Muazuddin Textile Ltd. (9998)

12.APRIL.2014

Identified Priority 1 Concern

1st Priority 1 Concern

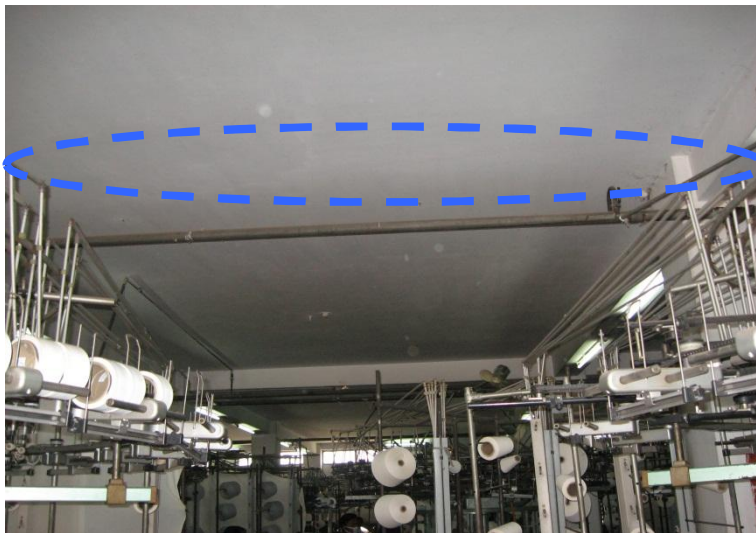
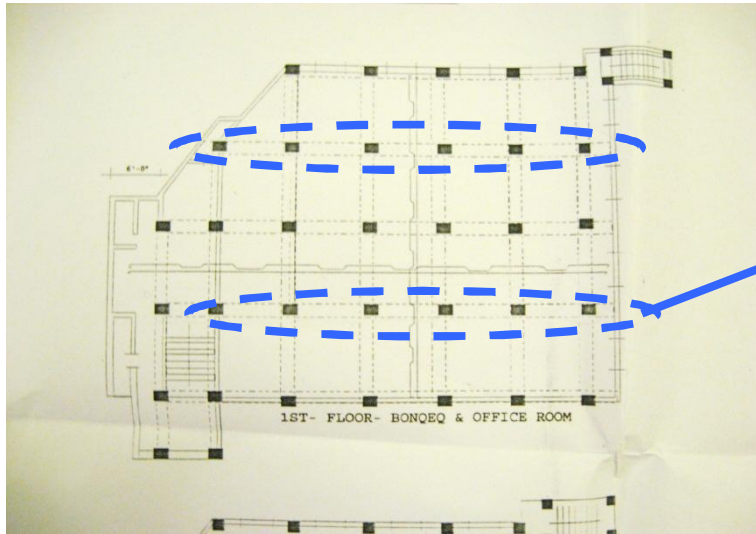
The interior column was supporting part the 4 part 5 storey building section above. However its size beneath the ground floor (column pier) was only 300x300mm - as specified in the drawing. From the calculation check, this column appears to be overstressed.

- Remove loading on 4th floor immediately and reduce stacking height to ensure total load does not exceed 1.0kPa on 1st floor to 3rd floor.
- Factory Engineer to review design, loads and columns stresses in area identified above.
- Verify in-situ concrete stresses either by cores or existing cylinder strength data for [the identified columns / cores from 4 columns]. Core sizes to be a minimum of 100 mm diameter.
- A Detail Engineering Assessment of Factory to be commenced immediately.

2nd Priority 1 Concern

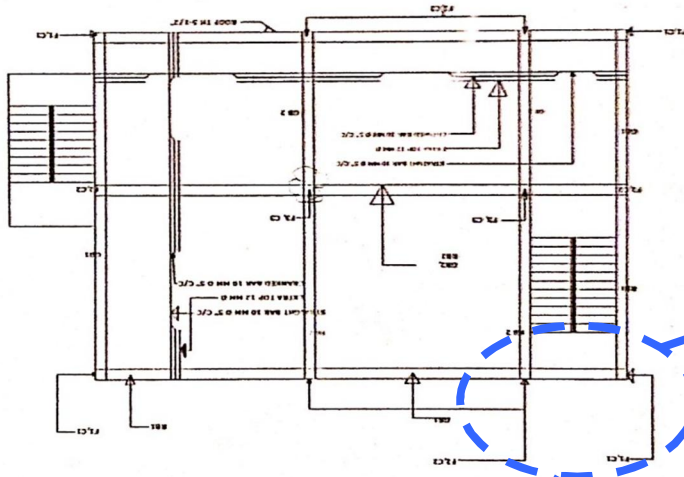
Two lines of the beam at 1st floor of Building 1 are not present. This is inconsistent with what specified on the provided drawings.

- Remove all storage loading from these areas.
- Factory Engineer to review design, loads, columns stresses to confirm suitability for applied loads.

1st Priority 2 Concern

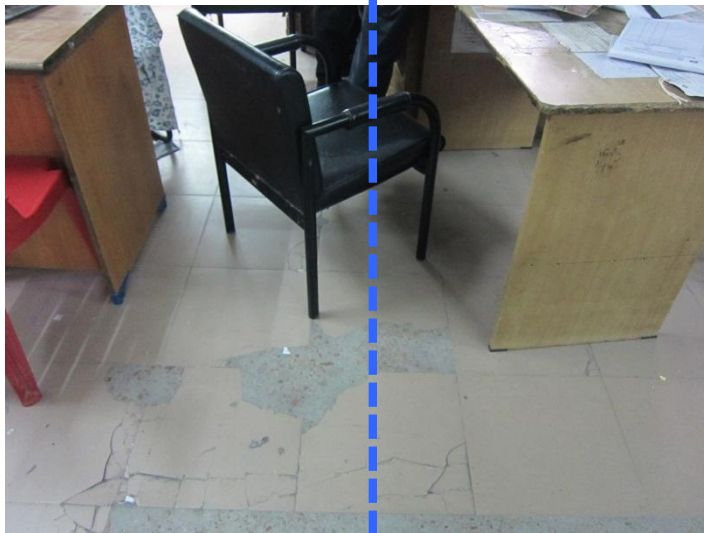
Concerns on roof's point load acting in the middle of RC beam where the depth of the beam is 250 mm spanning 3.50 m.

Slots for the support of steel rafters for boiler building are provided but there are no anchor bolts installed.

- Factory Engineer to review design, loads, roof and supports in area identified.
- Engineer to inspect roof supports and structure related to their function and propose a suitable repair if necessary.

3rd Priority 2 Concern

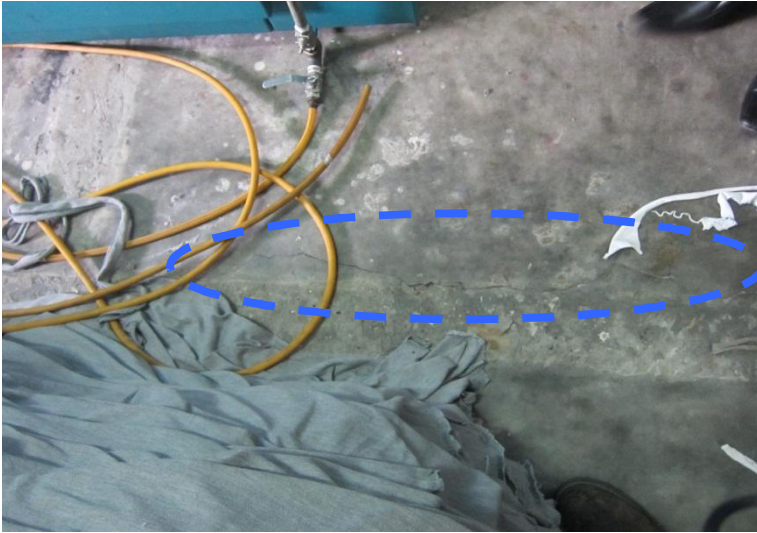
The factory buildings were constructed separately but no movement joint appears in the attached zone, between them.

----- Movement joint to be established properly

- The Factory's Building Structural Engineer should carry out a Detailed Engineering Assessment to prove the capacity of the building in its existing state, a further building approval should be gained for the building as it exists, as altered since the original approval. Alternatively, the extension building should be separated by a non-structural joint and allowed to act as a fully structurally independent structure.

4th Priority 2 Concern

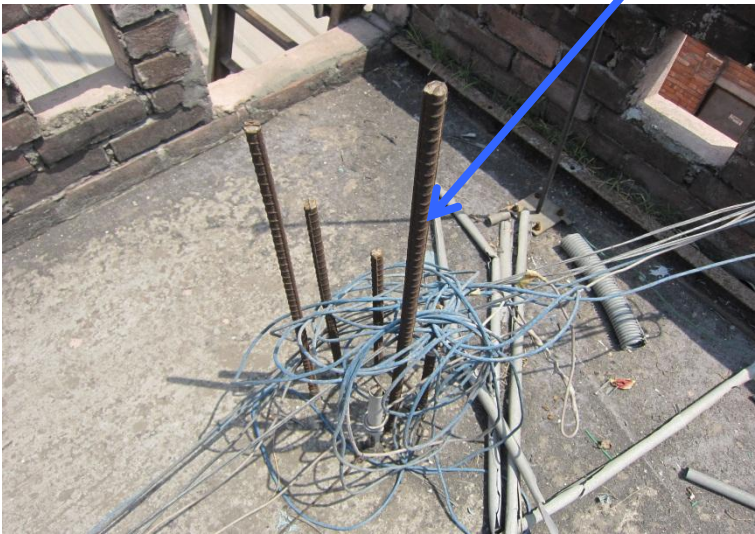
There are cracks on the top of ground floor slabs in Building 2. The ground floor slab is suspended.

- The Detail Engineering Assessment of this area to be carried out.
- The distress found is recommended to be repaired with proper methods. Repair by simple over-plastering work is not allowed.

2nd Priority 3 Concern

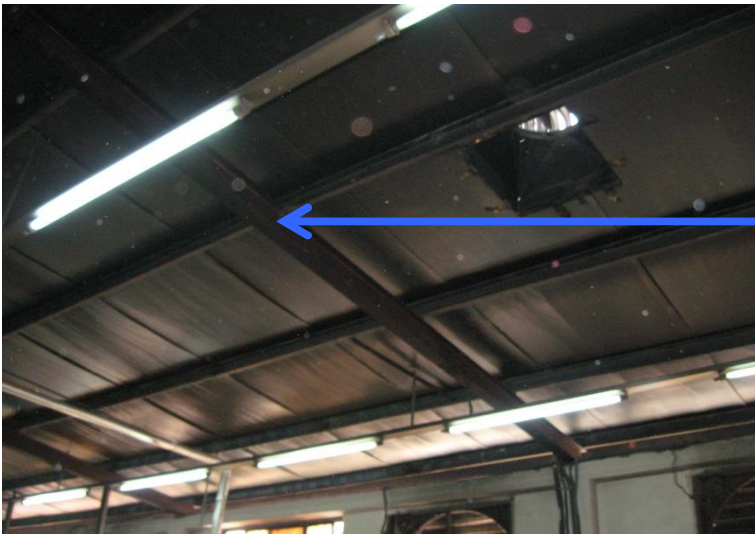
Structural steel elements in all buildings - confirmation whether fire proofing material is required.

- Fireproofing material for structural steel element is to be applied if required.
- Maintain standard of quality control.
